7009 GREENWOOD AVE N

Design Review Recommendation Meeting
May 1, 2017
SDCI Project # 3023260

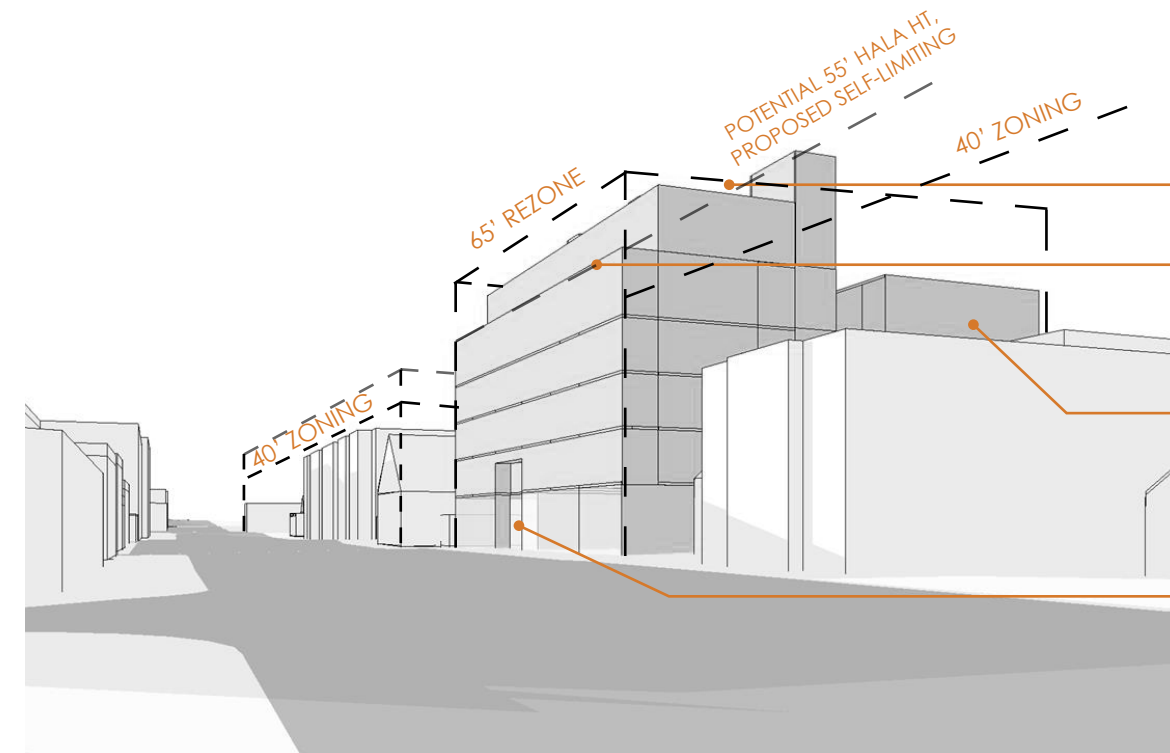
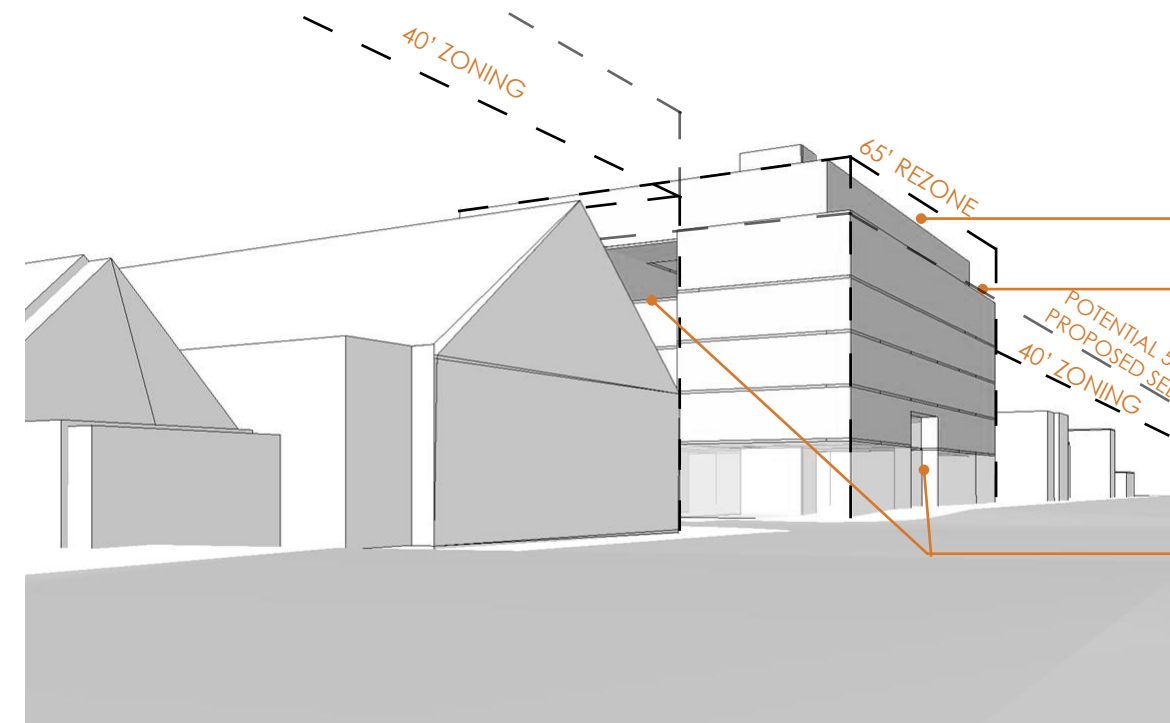
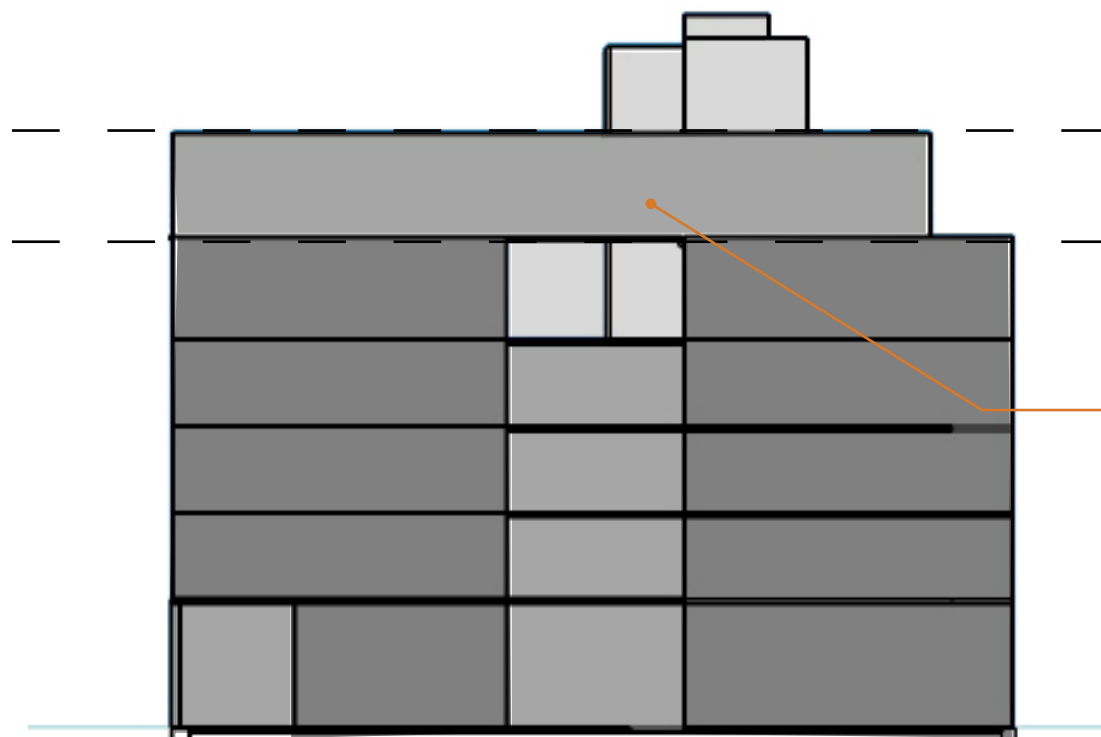
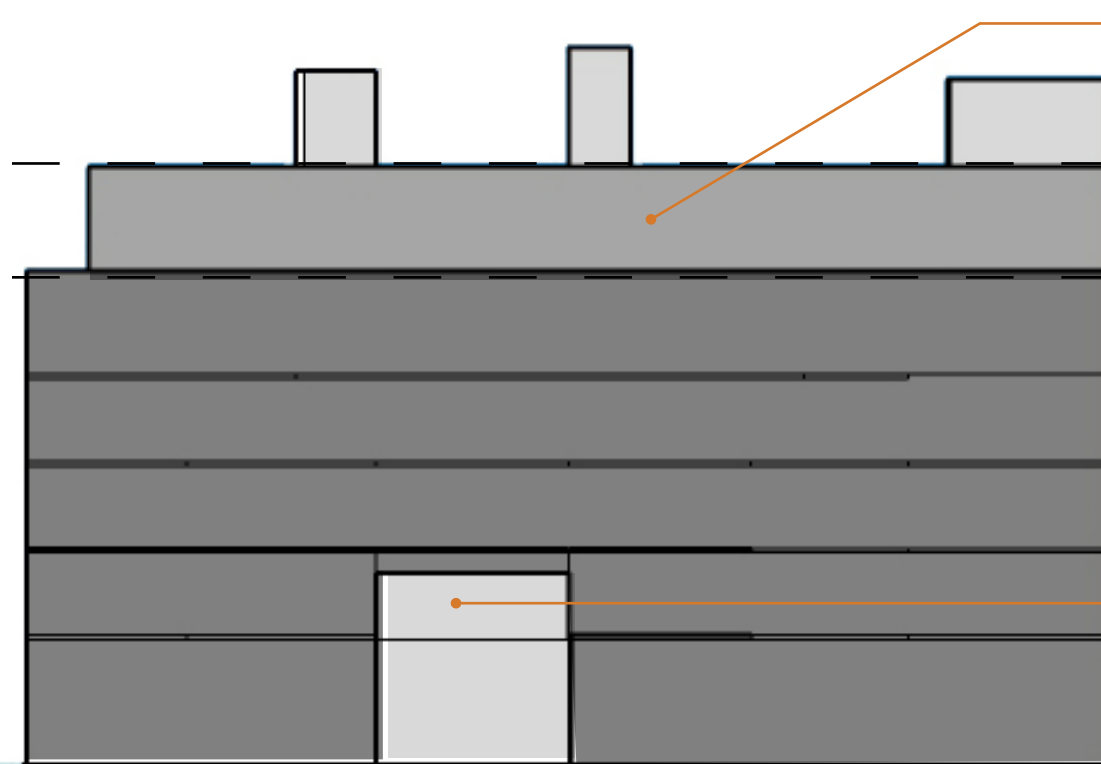
direction: the Board suggested that the “building massing should be further developed to provide thoughtful transitions between the proposed building and adjacent building and zoning context.” The Board requested to “maintain a strong street wall at ground level along Greenwood Ave N and N 70th St and develop upper level massing to respond to future massing context along each street.” The Board encouraged the design team to explore scale and proportion, review a possible 2-story setback, consider strategic erosion, modulation, fenestration, and material application to develop an appropriate massing response.

response: the scale and proportion of future building context (through the lens of the pending 55' HALA upzone) has been studied. This informed a decision to remove the upper (6th level) floor from EDG for a reduced building height of 5 stories to better align with anticipated future zoning. In response to EDG feedback, the top floor has been differentiated from the building base with a material change, providing a vertical break to reduce perceived building height. Strategic modulation is proposed along each frontage to reduce perceived mass: each facade features a vertical setback/break to divide the building into three distinct zones from each vantage point. Additionally, the west end of the south (70th St) facade sets back the upper floor at the west end to provide a scale transition towards the less-intensive single family use.

6th floor has been
removed

6th floor has been
removed

< figure-ground diagram showing proposed development within existing urban fabric

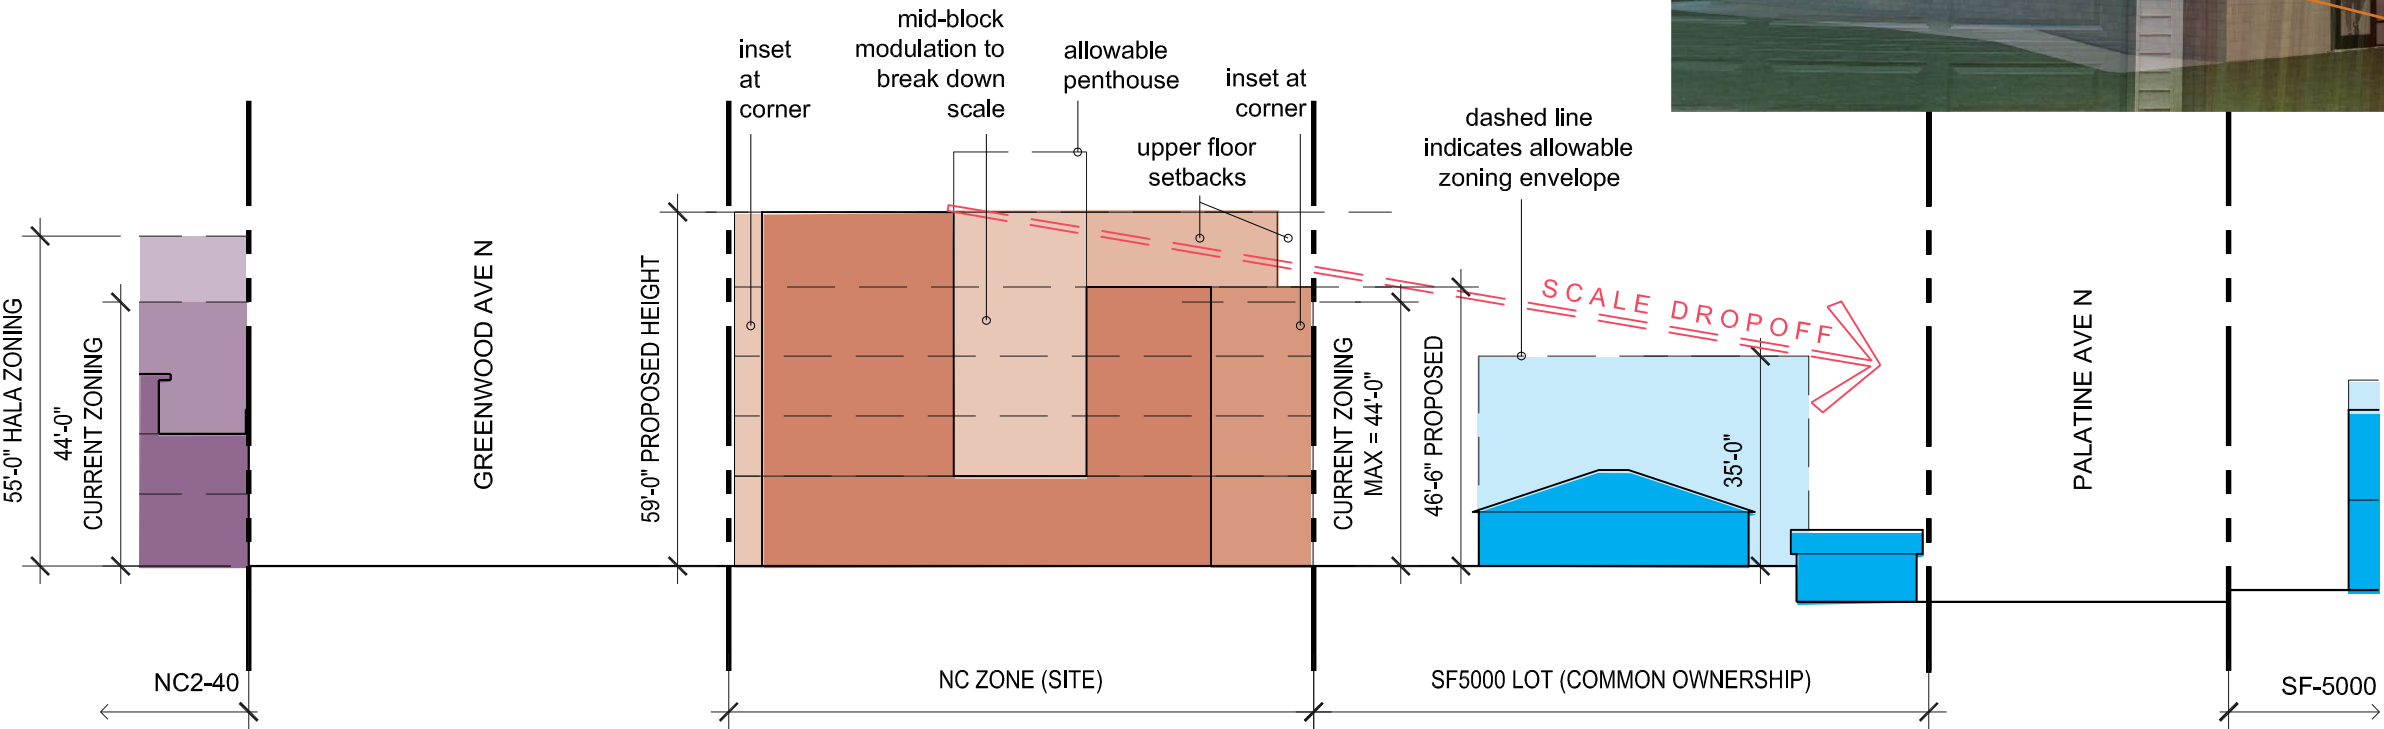
direction: the Board expressed concern regarding “building mass and shadow impacts of the increased height in relationship to the adjacent single family” uses. The Board requested a “thoughtful transition,” including a revised site design that includes the adjacent single family parcels that are part of the development proposal, utilization of landscaping and site design to provide a ground-level transition to adjacent uses

response: the project development site now includes two adjacent single-family parcels that border the entire length of the site to the west. The southwest single family parcel will be landscaped and the northwest single family parcel contains a single-family house that is to remain. The previous pedestrian cut-through from Greenwood Ave N through the interior courtyard to the west single-family parcel has been eliminated to provide more privacy and a buffer between retail and adjacent residential uses. The ground floor courtyard helps break the at-grade expression down to a scale that is on par with the existing fabric of the neighborhood

ELEVATION FROM NORTH (BLOCK INTERIOR)

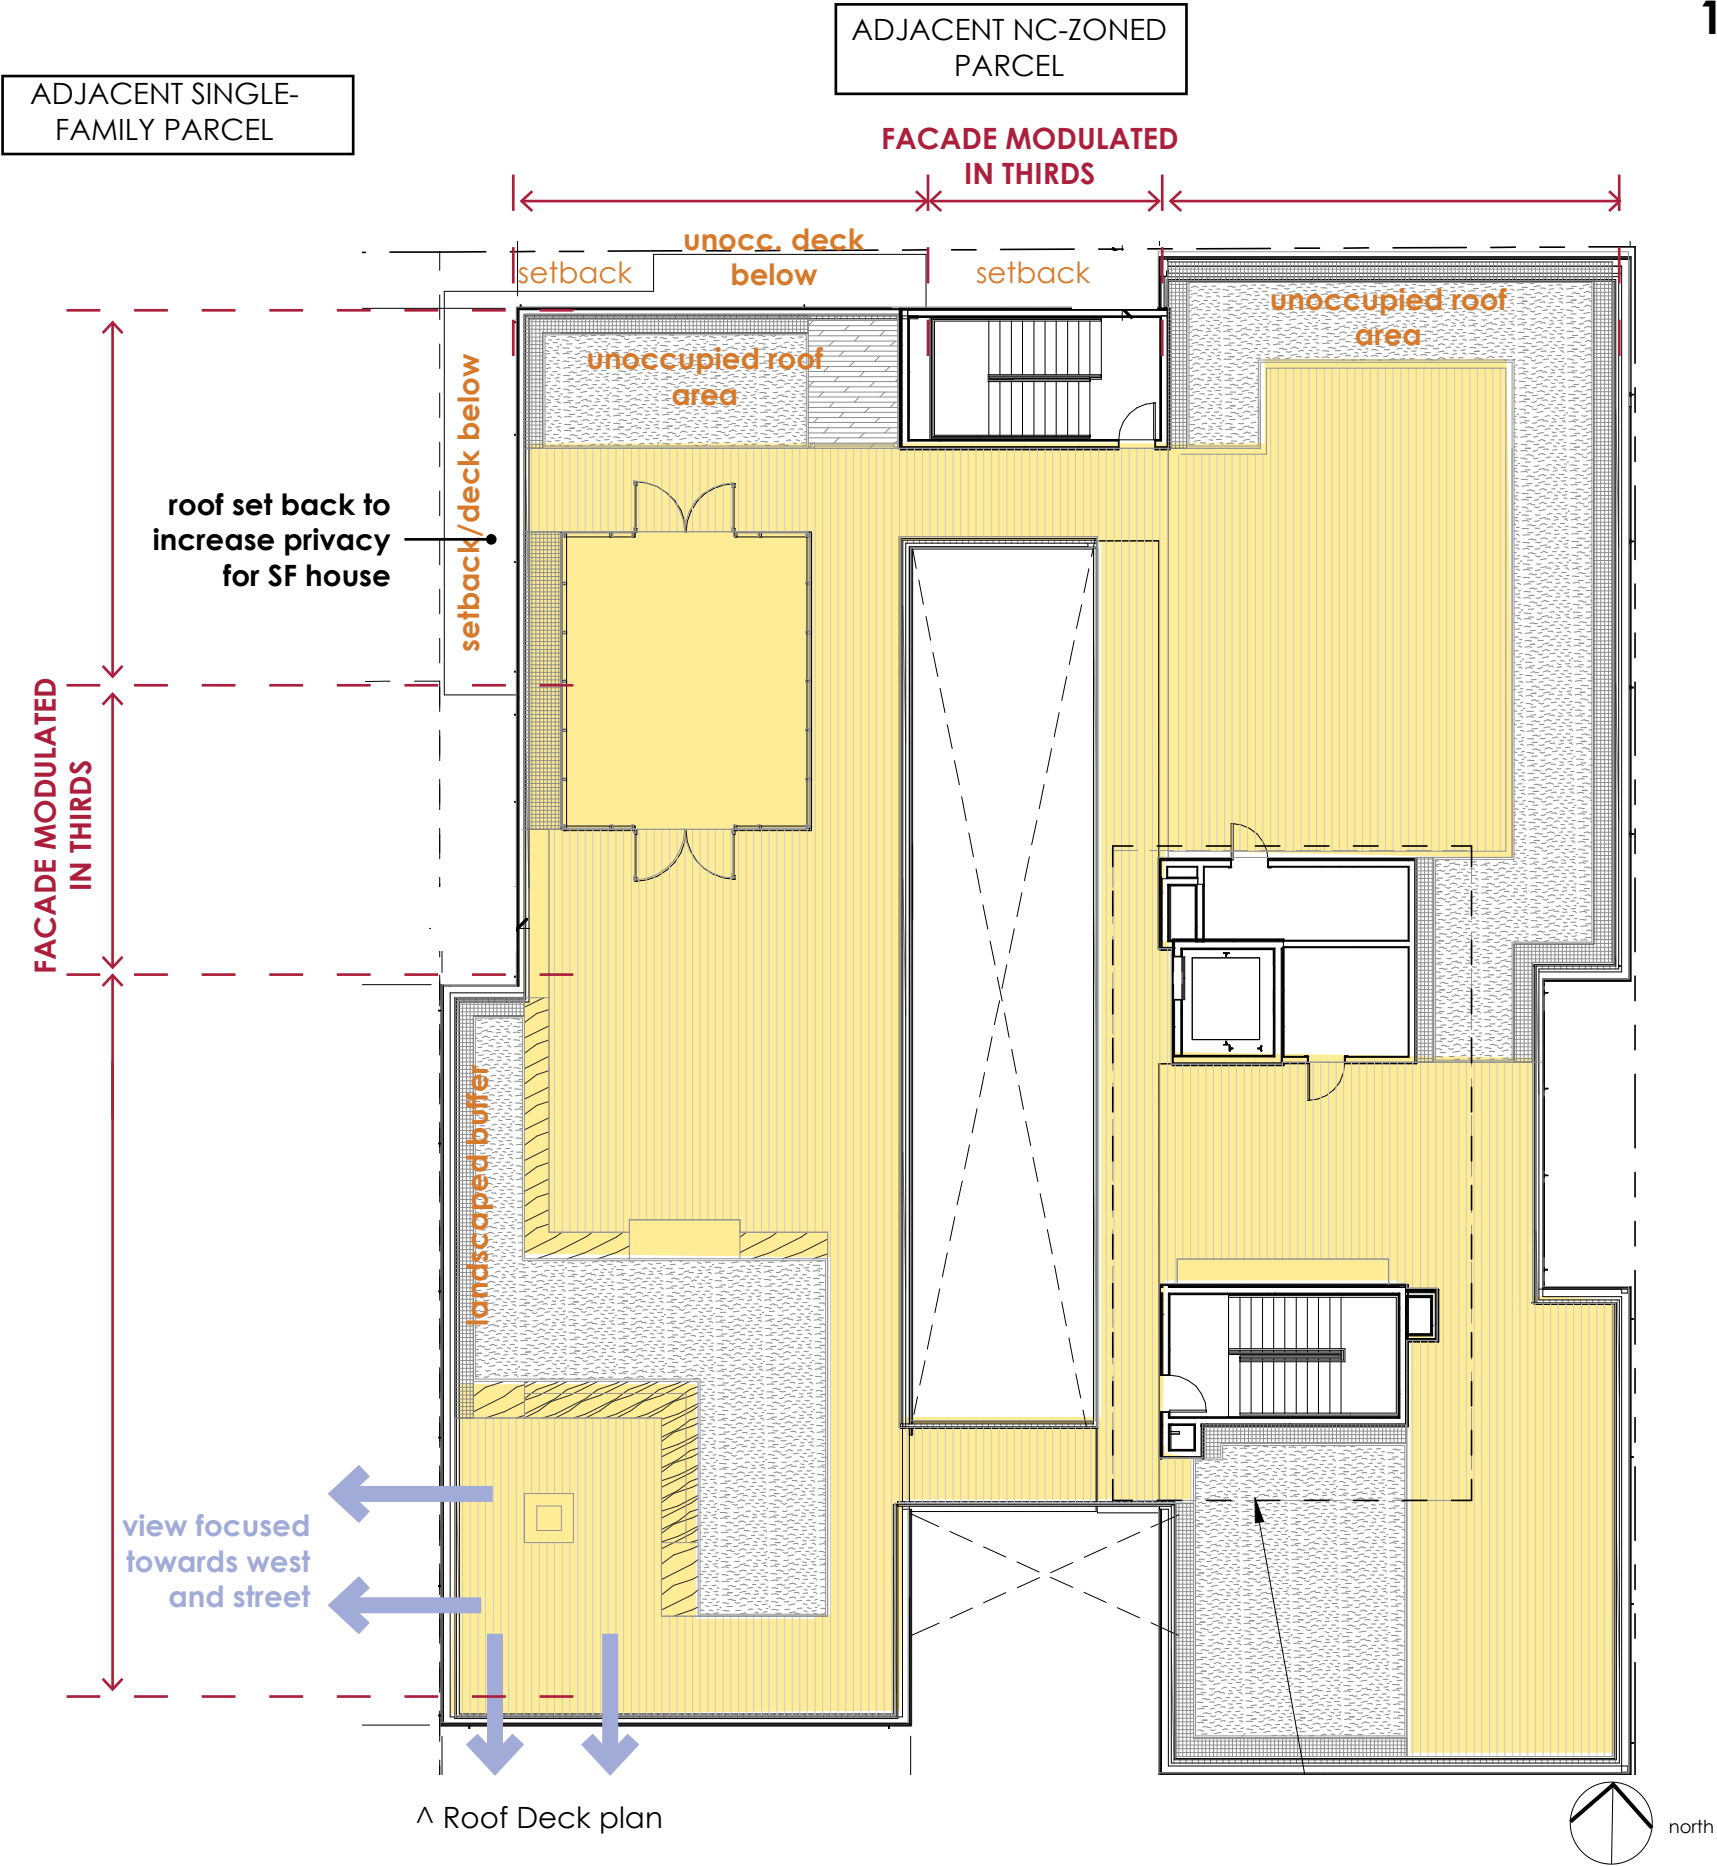
direction: the Board expressed concern regarding “building mass and shadow impacts of the increased height in relationship to the adjacent single family” uses. At the Recommendation Meeting, the Board requested a “thoughtful transition,” including the study of upper level massing to incorporate “meaningful and well-placed transitions” including upper-level setbacks, modulation, architectural detailing, and privacy studies.

response: building mass and shadow impact concerns raised at EDG have been reduced by eliminating the upper 6th floor (the current project proposal is 5 floors). Upper level massing includes setbacks facing west and at the west ends of the north and south facades, with a material change to transition to the less intensive neighboring single-family lots. Both the north and west facades also feature a mid-facade vertical setback/break along the facade to divide the elevations into three smaller parts.

- previous 6th floor has been removed from EDG proposal
- green screen for privacy to adjacent property
- upper floor setback and material change at 5th floor, NW corner
- setback/modulation to break up facade
- color change to reduce massing at northeast
- per neighbor's request, limited fenestration facing north property for privacy
- mid-block setback/modulation to break up facade
- ground floor pedestrian cut-through has been removed from EDG
- 10' wide landscaping buffer proposed on single-family parcels under common ownership
